PERRY NUCLEAR POWER PLANT
10 CENTER RD., PERRY, OHIO 44081

Information Only
New Figure

Information Only
CN=Change

FIGURE 2D-3

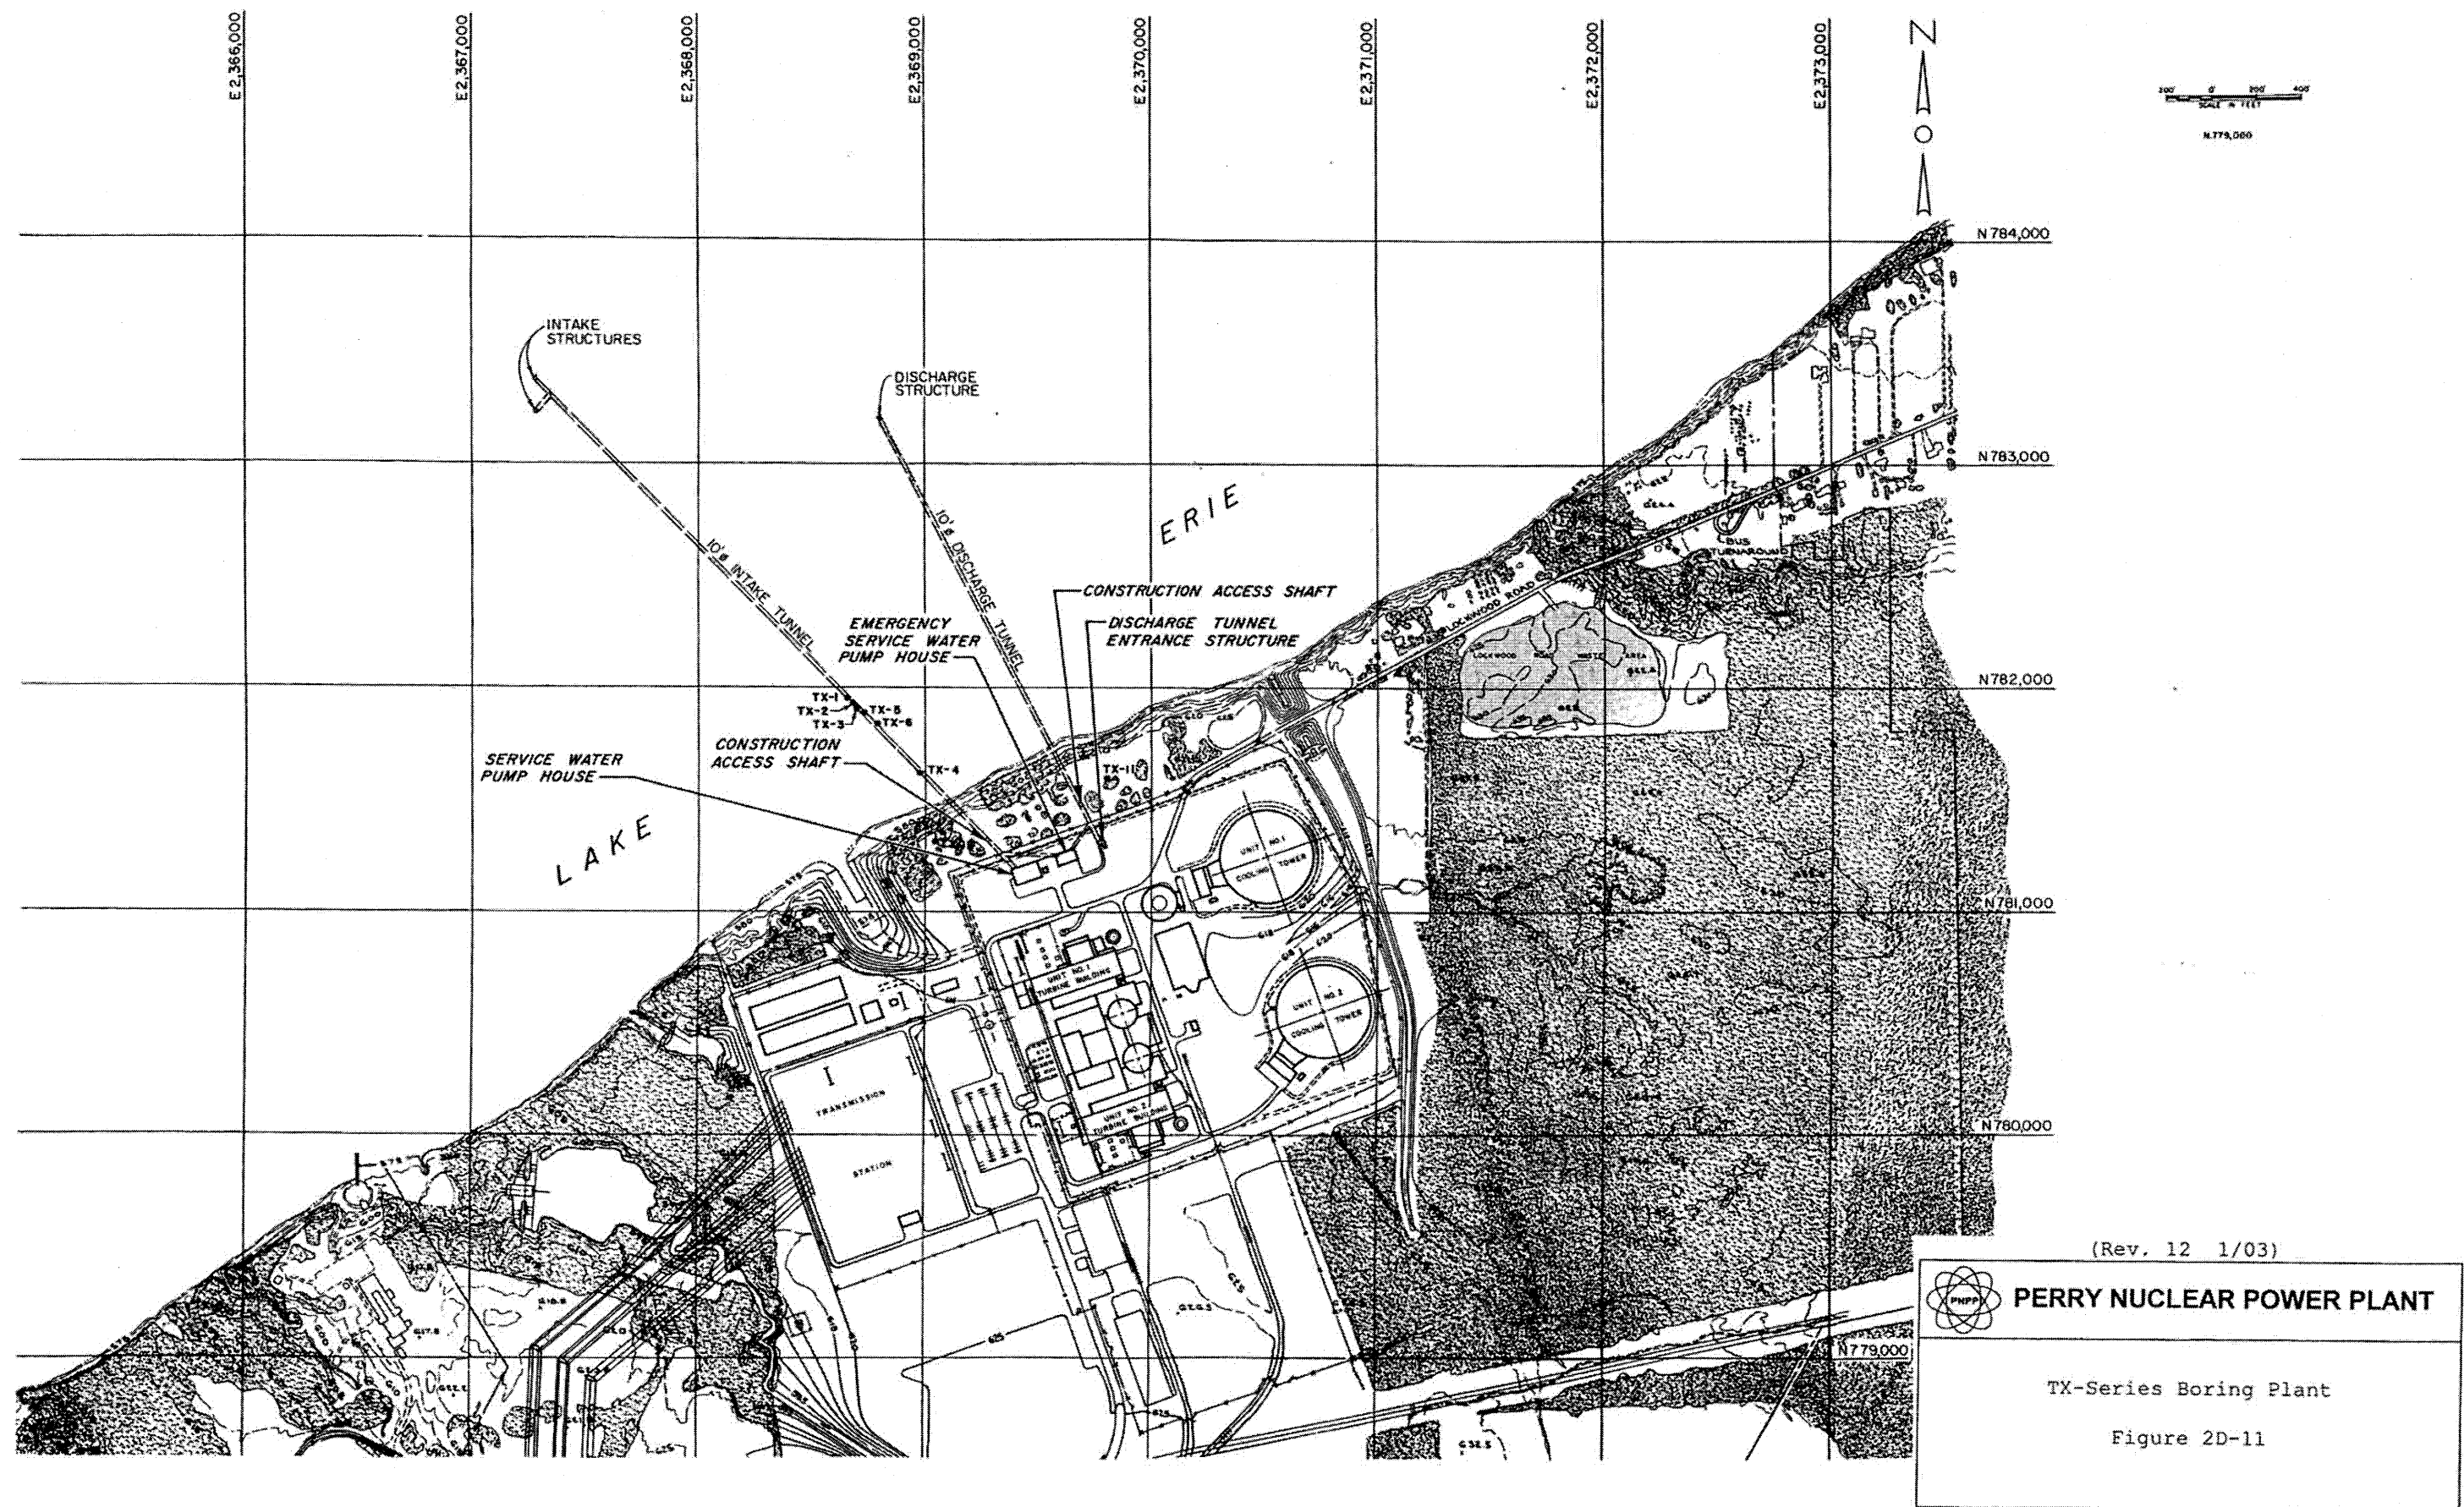
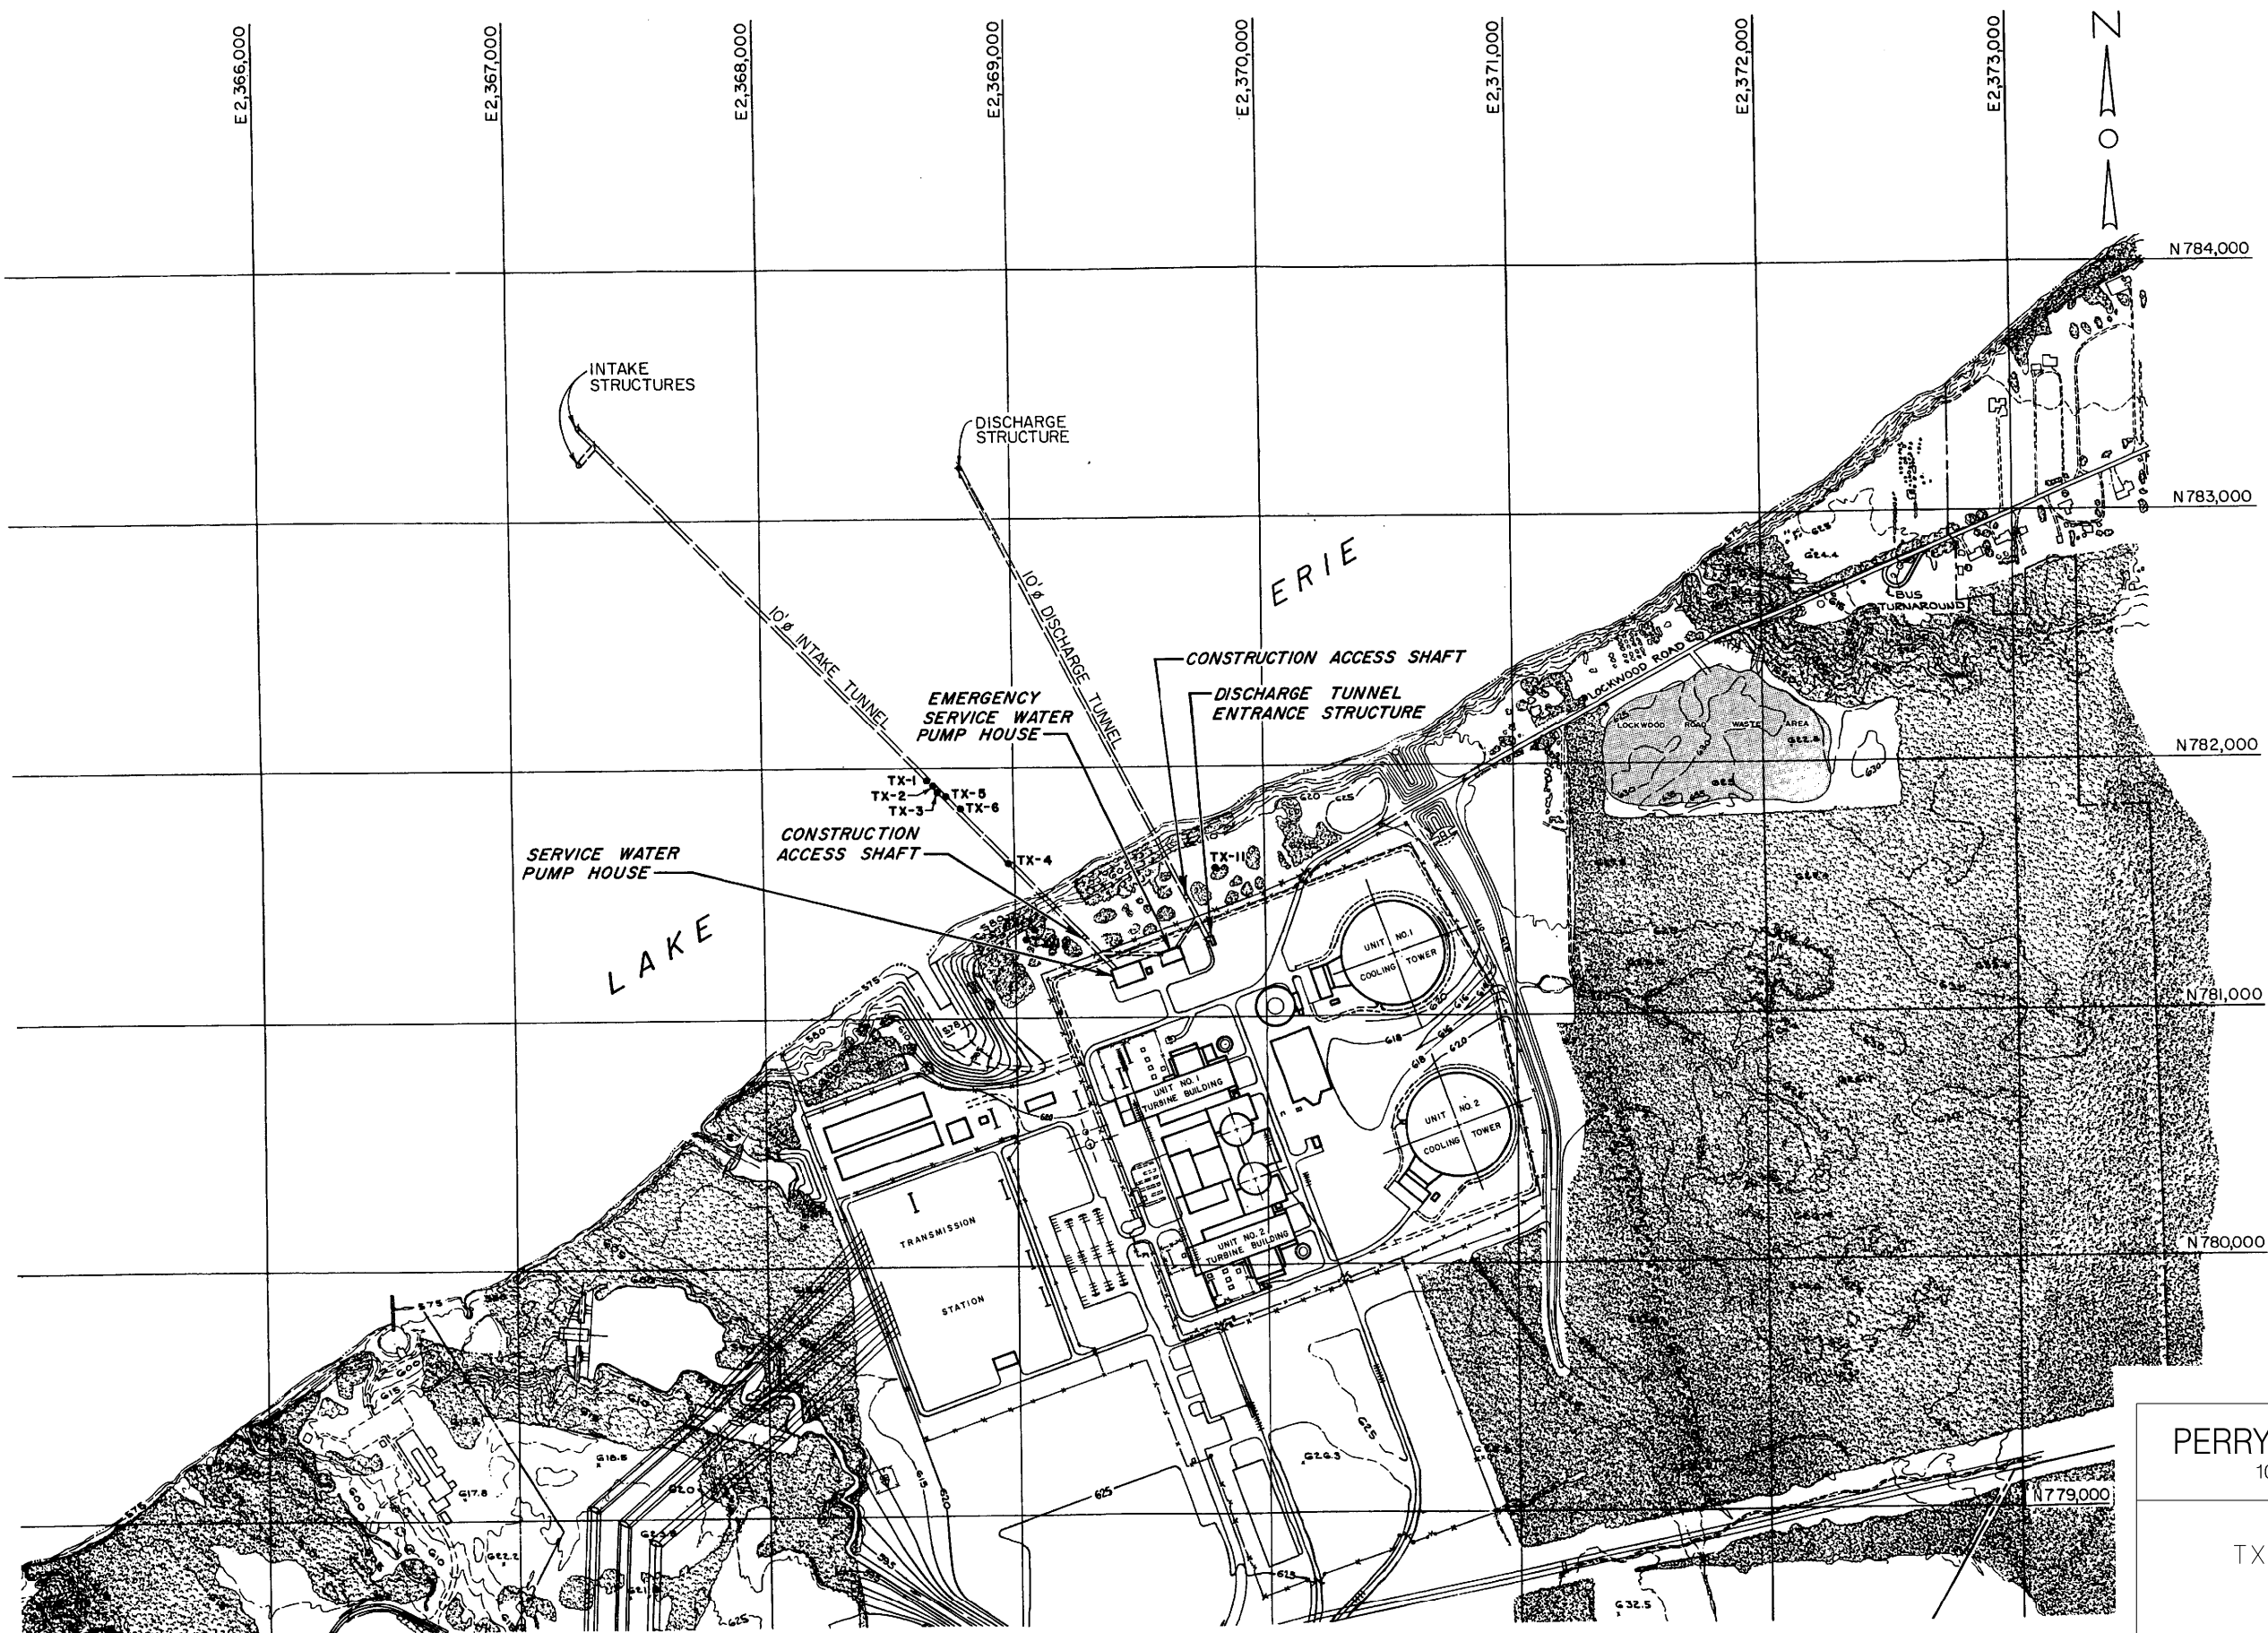
ADD NOTE
THIS CN

NOTE:
THIS USAR FIGURE CONTAINS HISTORICAL
TOPOGRAPHICAL INFORMATION FOR REFERENCE
ONLY AND WILL NOT BE UPDATED.

Figure 3.8-81

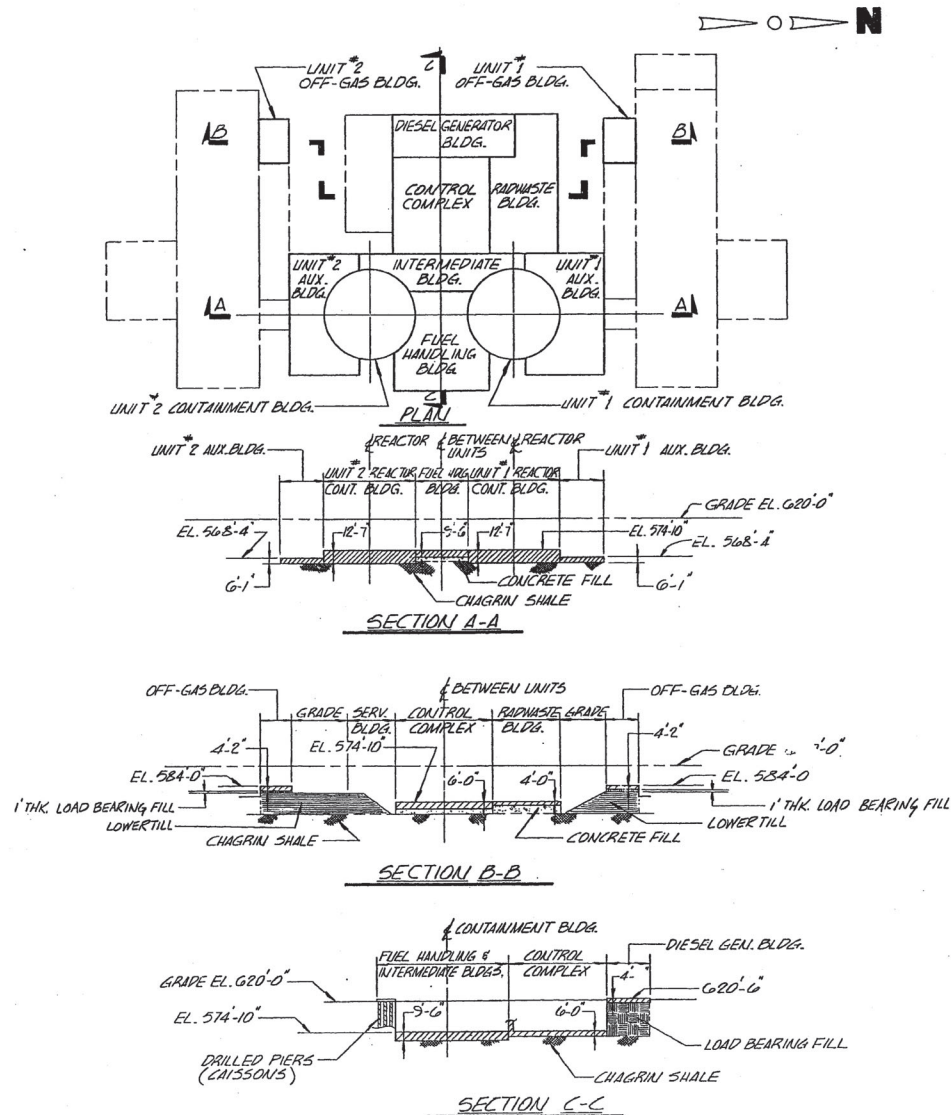
ADD NOTE
THIS CN

NOTE:
THIS FIGURE CONTAINS HISTORICAL
INFORMATION REGARDING PLANT GRADE
ELEVATION. THIS INFORMATION IS FOR
REFERENCE ONLY AND IS NOT UPDATED
